DP20-0003 & DVP20-0004 815 Leon Ave.

Development Permit &
Development Variance Permit Application

Variance 3

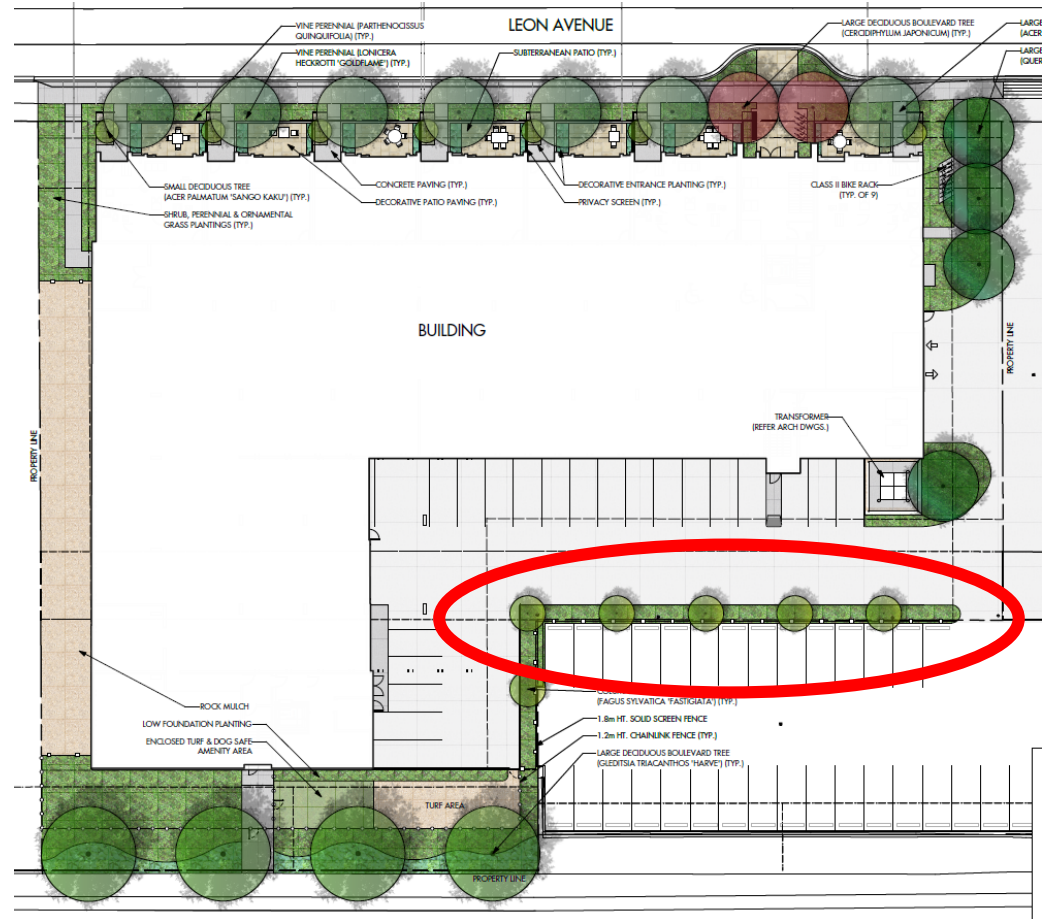
- ▶ Reduce the landscape buffer for a portion of the rear yard from 3m required to 1.1m.
- ▶ Area wherein the landscape buffer is reduced fronts onto a parking area on an adjacent lot where the need for extensive landscaping is less crucial.
